LAND USE APPLICATION

PROJECT NO. PRJ19-00008

**FILE NOS. SDP20-00001, MSP20-00001, AAS20-00012,
AAS21-00001, AAS21-00002, AAS21-00005, & AAS20-
00006**

**ISSAQUAH HIGH SCHOOL #4 & ELEMENTARY SCHOOL #17
PROVIDENCE HEIGHTS
4221 228TH AVENUE SE**

Figure 7: High School Build-To-Line. Annotations by Staff. Source: ISD (Attachment 97, Sheet C1.0LU – Civil Plans).

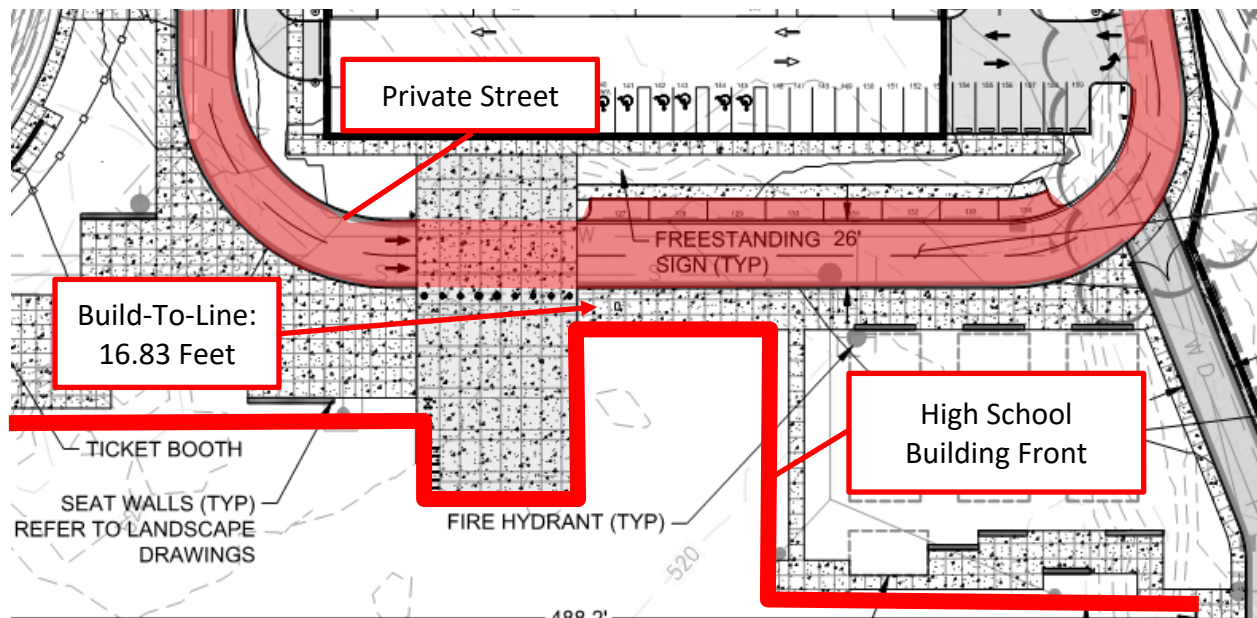
(parallel) parking. The site plan indicates the high school is approximately 16.83 feet from the private street edge (Figure 7, below) and the elementary school is approximately 18.5 feet from the private street edge (Figure 8, on the following page).

Figure 10: ADA Route. Annotations by Staff. Source: ISD (Attachment 97, Sheet C1.0LU – Civil Plans).

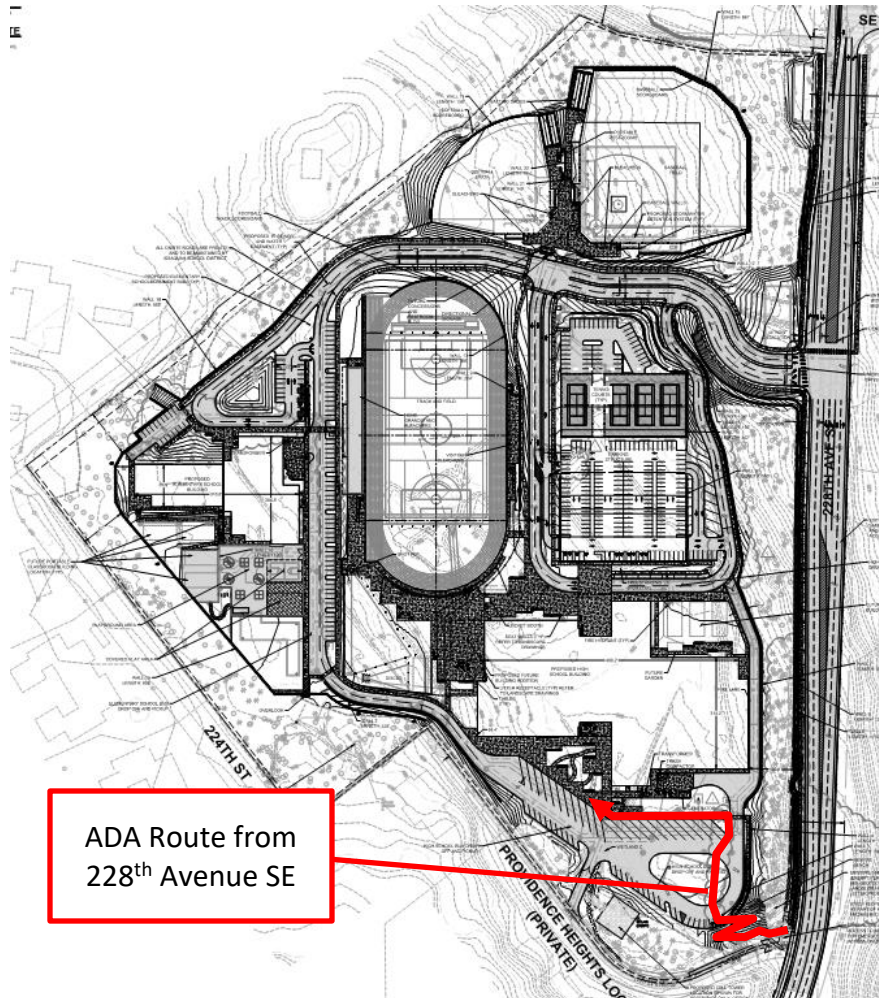
The Applicant is required to provide barrier-free (ADA-accessible) walkways through a development between public entrances and the nearest public sidewalk using the most direct route through the development pursuant to IMC 18.07.080(B)(1)(b). Due to the grade of the entry boulevard, which is not ADA compliant, the Applicant provided a separate ADA-accessible route from the proposed public sidewalk along 228th Avenue SE (see Figure 10 on the following page). The ADA-accessible route is located at the southeast corner of the property and connects to the south student entrance of the high school by traveling northward along the east side of the bus loop (Attachment 97 – Civil Plans). This is the most direct route possible due to the grade of the property along the 228th Avenue SE frontage. 228th Avenue SE does not currently provide pedestrian or bicycle infrastructure in the vicinity of the site, but the proposed frontage improvements will connect nonmotorized access from SE 40th Street to Providence Point Drive SE. The interior nonmotorized network from the main intersection southward is ADA-accessible and barrier-free except for a steeply-sloping portion of the elementary school roadway in the vicinity of the softball outfield. The interior nonmotorized circulation network provides extensive direct routes to each of the proposed buildings, structures, and amenities and connects to the 228th Avenue SE frontage.

CONCLUSION: The proposal complies with IMC 18.07.080(B)(1)(b).

Figure 11: Proposed Nonmotorized Frontage Connections. Source: ISD Application Materials (Attachment 97, Sheet C2.0LU – Civil Plans).

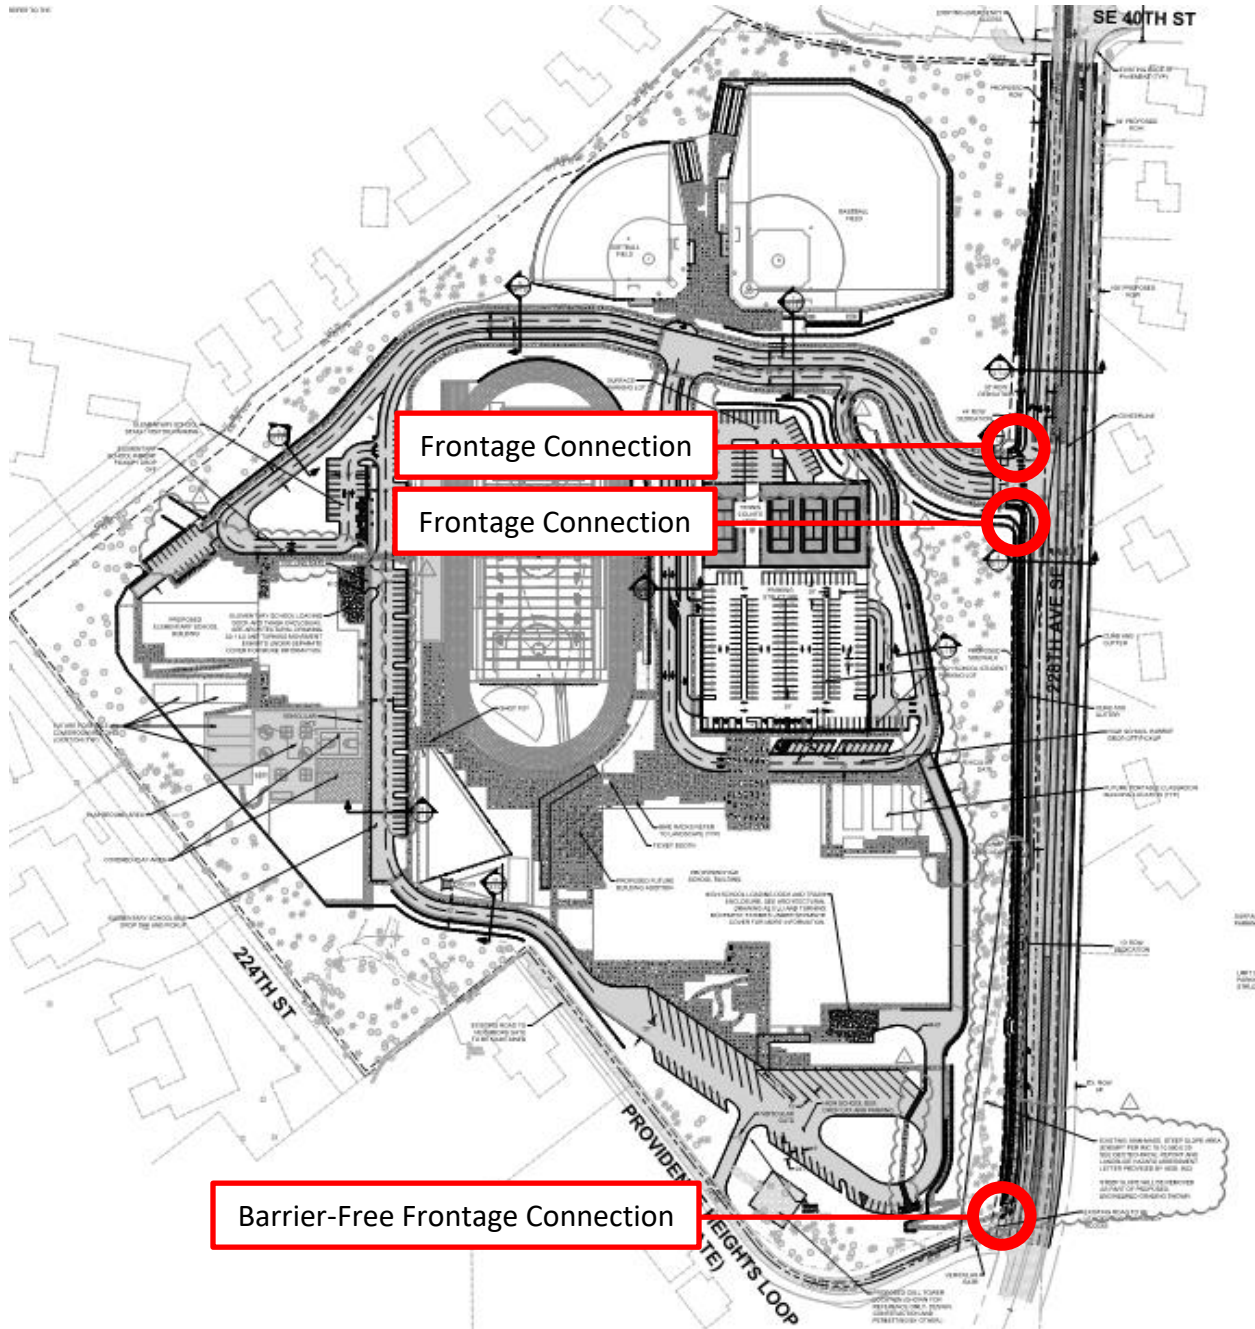
The Applicant has requested an AAS (**Permit no. AAS21-00006**) to reduce the number of required frontage connections from eight to three pursuant to the AAS criteria in IMC 18.07.080(C), identified in Figure 11, below.

Staff Analysis: The proposed frontage connections are shown in Figure 11, on previous page. According to IMC 18.06.090, the intent of the CF-F zone is to provide for service-oriented development for the larger community that is compatible with surrounding land uses, safe and functional, and consistent with Issaquah’s Comprehensive Plan. As described in Section VII.A.7 of this Staff Report (above), the project is consistent with the purpose and intent of the CF-F zone. The proposal meets applicable dimensional requirements for building massing to ensure compatibility of scale with the surrounding community and is required to comply with applicable design requirements for buildings in the CF-F zone. The proposed adjustment is consistent with the character of other, similar facilities along 228th Avenue SE, including Skyline High School and Pine Lake Middle School. The proposal satisfies this criterion.

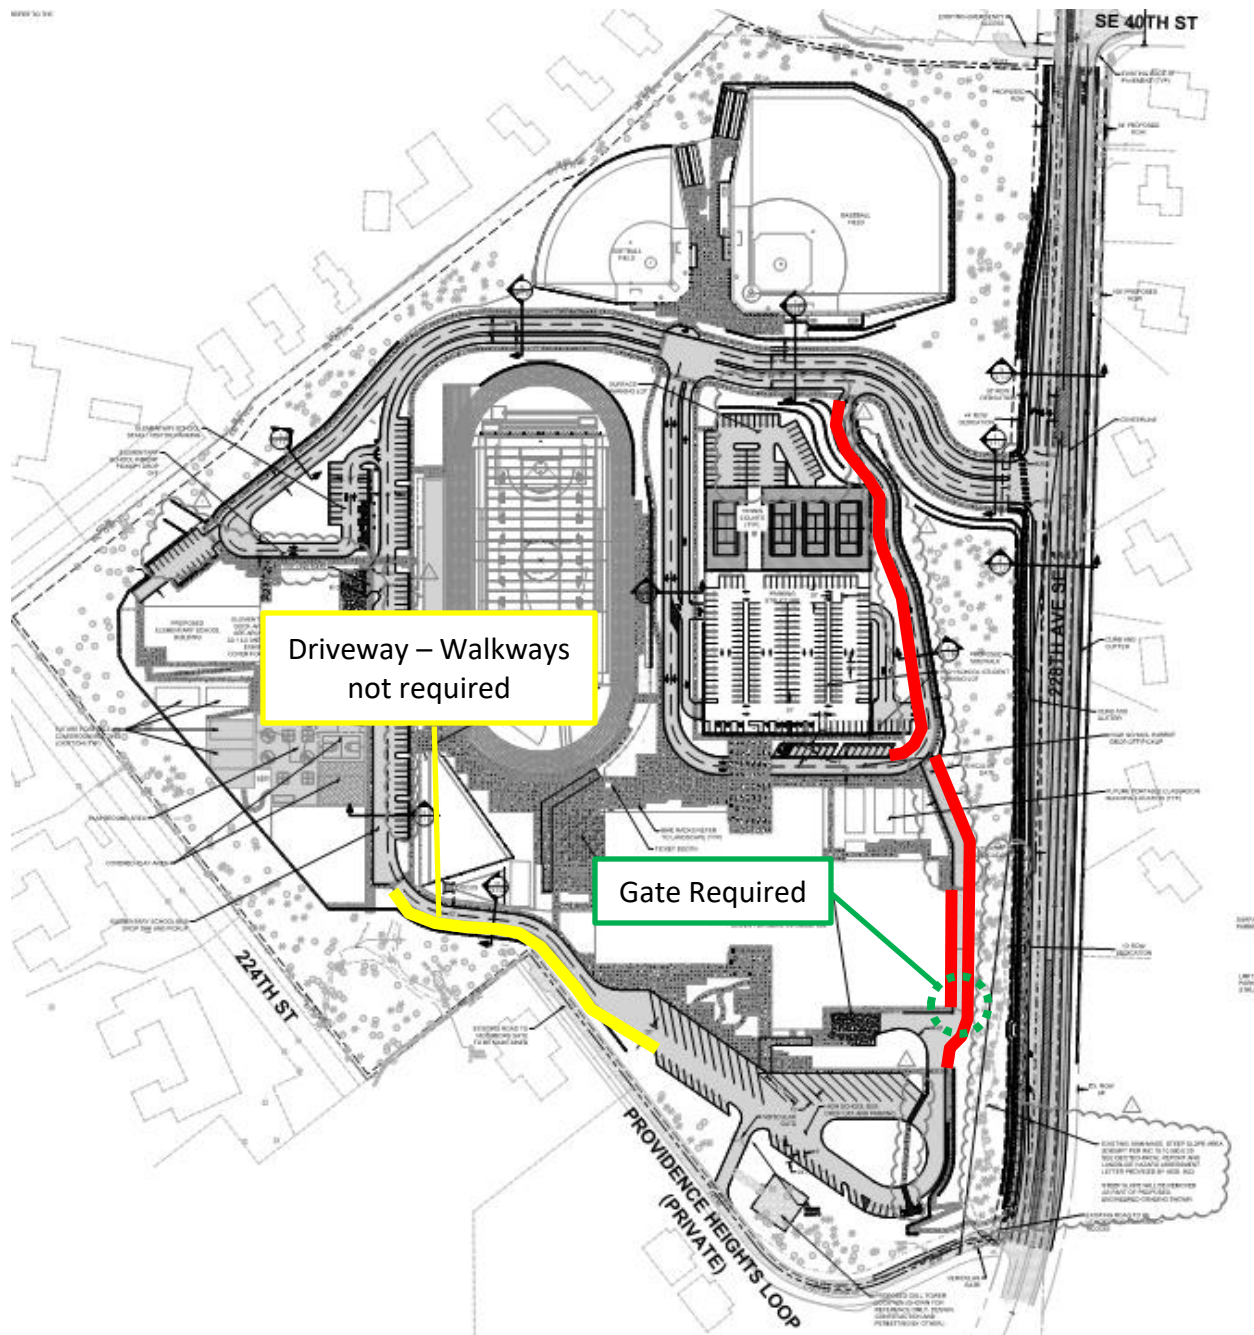
The Applicant has provided an extensive internal nonmotorized network that links all public entrances of the buildings and athletic facilities to each other and to the proposed sidewalk along 228th Avenue SE (Attachment 97, Sheet C2.0LU – Civil Plans). The proposed walkways are generally parallel to and continuous along all sides of the building facades with public entrances; there are no walkways proposed on the east side of the high school building, where emergency access and service vehicles may travel, but there are no public entrances on that side (Attachment 97, Sheet C2.0LU – Civil Plans). Pedestrian connectivity is provided around, through, and to parking lots and the parking structure (Attachment 97, Sheet C2.0LU Civil Plans and Attachment 99, Landscape Plans). The walkways do not result in any dead ends or unnecessary road crossing or circuitous routes. Note that the bus loop driveway extends from the bus parking lot to the south end of the elementary school's eastern access road and walkways are not required on both sides of the driveway. The Applicant has generally provided a continuous walkway on both sides of the roadways through the development except in certain locations. The Applicant is proposing to provide walkways on only one side of the roadways in the following locations: the west side of the east (exiting) half of the high school pick-up/drop-off road, along the entire west side of the emergency access drive on the west side of the high school, and adjacent to the building on the east side of the emergency access drive on the west side of the high school (see Figure 12 on the following page).

CONCLUSION: The Applicant requires an AAS to approve the proposal.

Staff Analysis: The proposed adjustment will relieve the Applicant from providing walkways on the west side of the east (exiting) half of the high school pick-up/drop-off road, along the entire west side of the emergency access drive on the west side of the high school, and adjacent to the building on the east side of the emergency access drive on the west side of the high school (see Figure 12, on previous page). These are internal walkways that will not impact adjacent properties or the visual character, scale, and design compatibility of the project with the surrounding area. The safety of the general public, and of site users in particular, will also not be negatively impacted. Ample pedestrian connectivity is available throughout the site, and student safety is protected by eliminating pedestrian walkways in these areas by preventing access in areas with limited supervision and preventing unnecessary street crossings. The proposal complies with this criterion.

Figure 17: Parking Structure Code Compliance Diagram. Source: ISD (Attachment 99, Sheet L2.5LU – Landscape Plans).

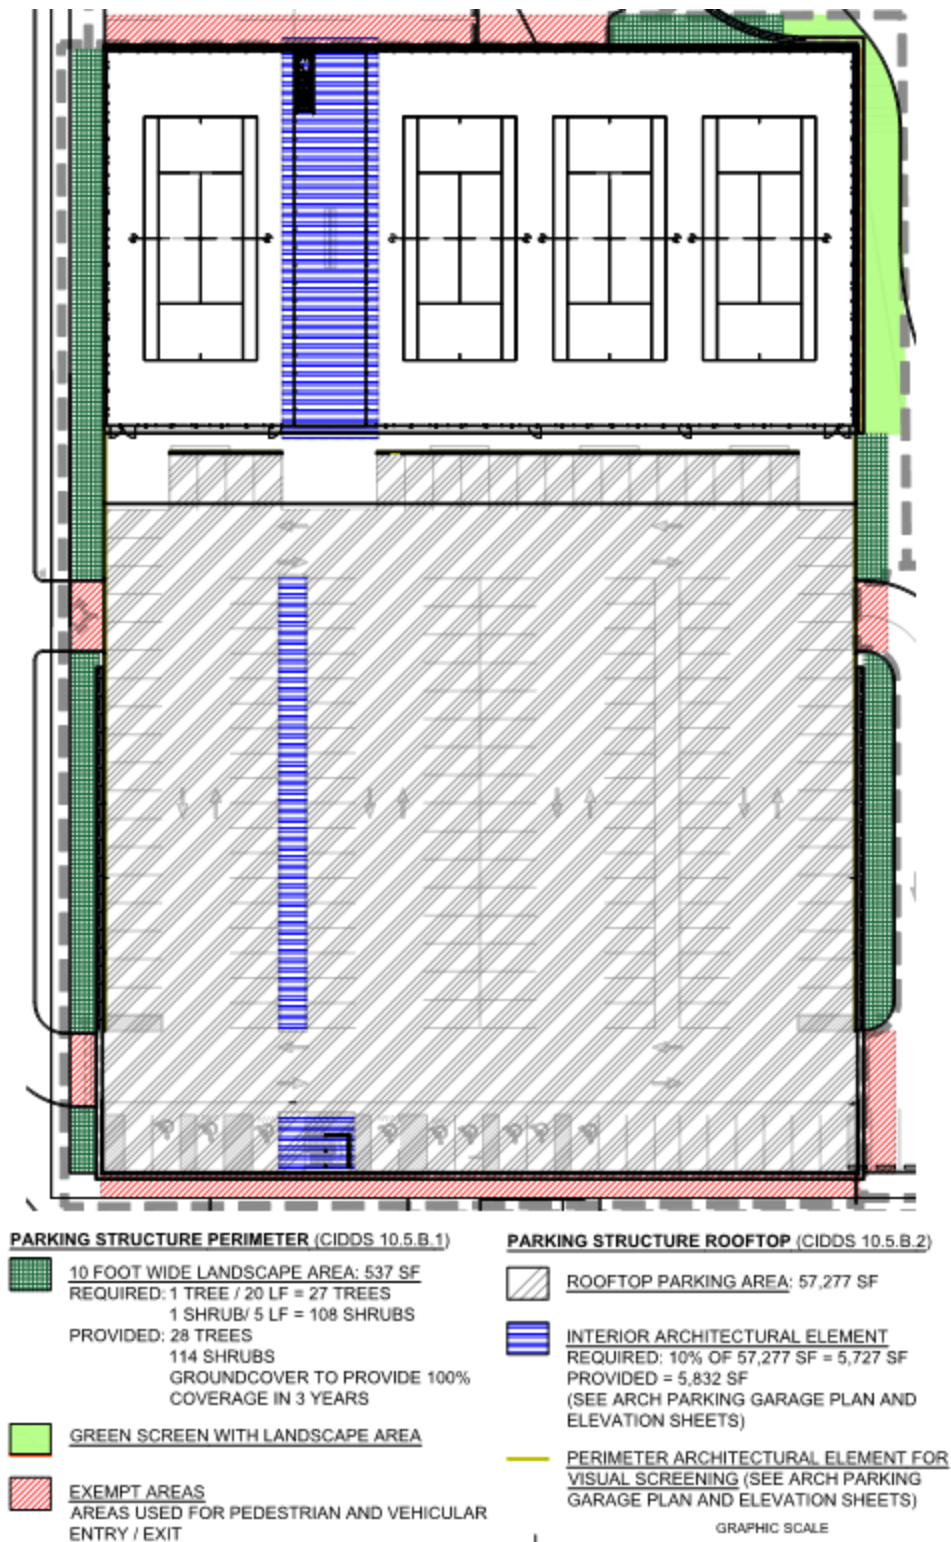
In addition, the Applicant is proposing rooftop treatments meeting the requirements of CIDDs 10.5.B.2.a.1-2 by providing an architectural cover over the pedestrian walkway, shown in Figure 17, on the following page. The parking structure is 57,227 square feet in size and requires an architectural component at least equal to 10 percent of the parking area, or 5,723 square feet. The proposed covered walkway will be 5,832 square feet in size, which exceeds the minimum requirement. When using architectural elements, the Applicant must demonstrate that they meet the intent of rooftop landscaping requirements to soften the visual appearance of the rooftop, screen views of the rooftop, add shade, break up the visual appearance of rooftop parking, and reinforce safe pedestrian access to stairwells and elevators. The proposed pedestrian cover, including the portion extending northward between the tennis courts to overlook the surface parking lot and campus areas below, meet the intent of rooftop landscaping requirements by providing visual interest, adding shade, breaking up the appearance of the parking areas, and reinforcing safe pedestrian access to stairs on the north side. The Applicant has indicated that a rooftop perimeter architectural element is proposed for visual screening, which must be at least 3 feet in height per CIDDs 10.5.B.2.b.1 (Attachment 99, Sheet L2.5LU – Landscape Plans) but the materials lack adequate information for review. The Applicant will be required to provide an architectural element detail for review and approval by the Community Planning and Development Director or her designee with construction permits for the parking structure. **[CONDITON 21]**

CONCLUSION: As conditioned, the project complies with applicable parking structure perimeter and rooftop landscape requirements.

Figure 18: Planting near Wetland B. Annotations by Staff. Source: ISD (Attachment 99 – Landscape Plans).

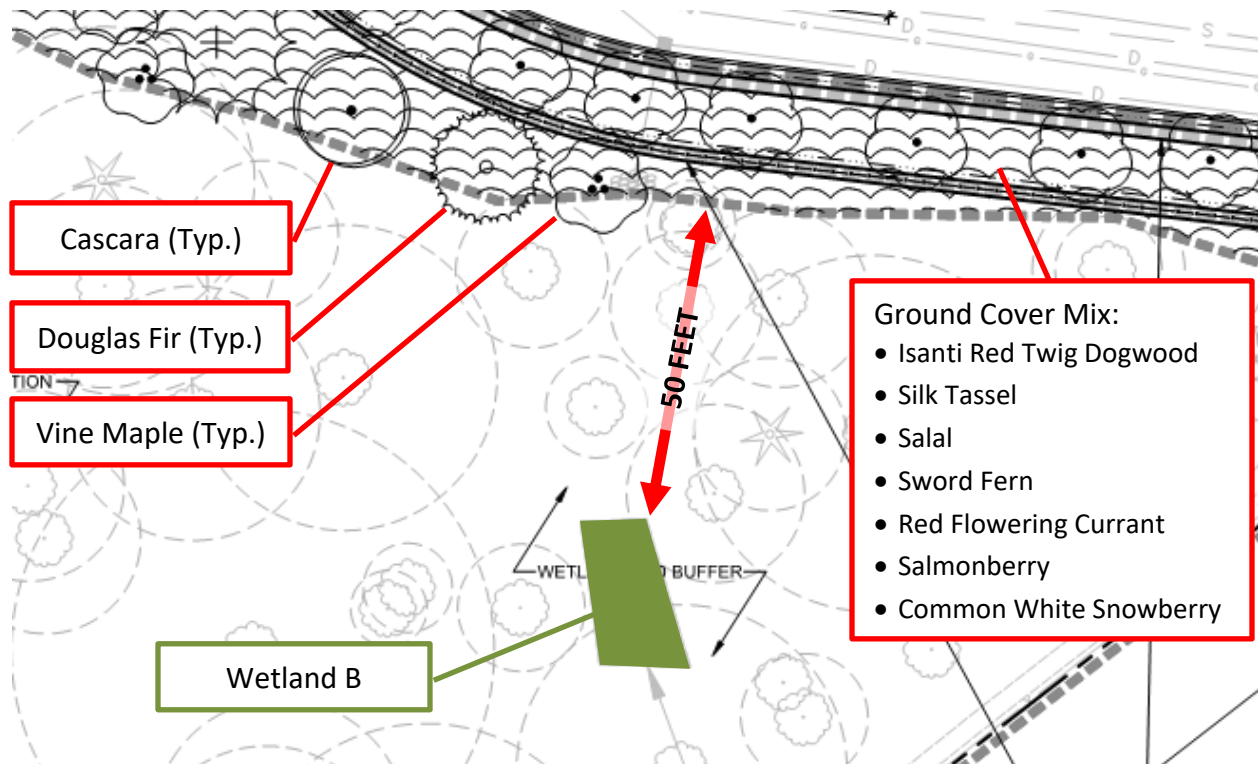
CIDDS 10.7 encourages the retention of native vegetation adjacent to critical areas and their buffers. Wetlands present on the property are discussed in further detail in Section VII.B.2 of this Staff Report. The Applicant is proposing to protect and leave undisturbed Wetland B and a 50-foot buffer of existing vegetation around the wetland. No plant materials whose seeding methods or growth patterns are likely to result in migration into critical areas and their buffers are proposed, as shown in Figure 18, below; proposed plants are native species. These requirements do not apply to Wetland C because it will be filled as part of the proposal (see Section VII.B.2 of this Staff Report for additional information).

CONCLUSION: The proposal complies requirements for planting near critical areas.

Figure 23: Wetland B. Source: ISD (Attachment 38, Page 63 – Critical Area Study & Wetland Mitigation Plan).

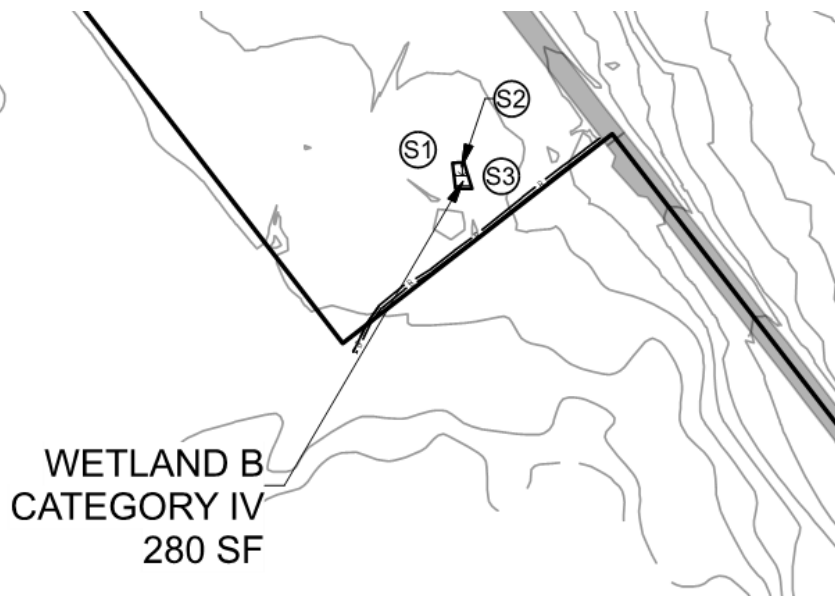
Wetland B is located in the southwestern corner of the property, near the intersection of 224th Lane SE and SE 42nd Terrace at Providence Point, shown in Figure 23, below. Wetland B is a seasonal palustrine wetland classified as a depressional wetland and has a multi-stratum vegetation structure comprising a forested vegetation classification (Attachment 38 – Critical Area Study & Wetland Mitigation Plan). The wetland scored 15 points on the Department of Ecology’s Wetland Rating Form for Western Washington, resulting in a Category IV classification per IMC 18.10.620, the lowest classification. The wetland scored four (4) points for habitat functions, which is a low habitat value score. The wetland is approximately 280 square feet in size. Pursuant to IMC 18.10.640(C), Category IV wetlands less than 2,500 square feet in size do not require a buffer. Wetland B and a 50-foot voluntary buffer will be protected in the proposed vegetated buffer area between the school facilities and the Providence Point community. Wetland B will be a site feature for students and visitors viewable from an overlook at the elementary school playground but will not be accessible to students or visitors.

CONCLUSION: The project complies with applicable requirements for Category IV wetlands less than 2,500 square feet in size with respect to Wetland B.
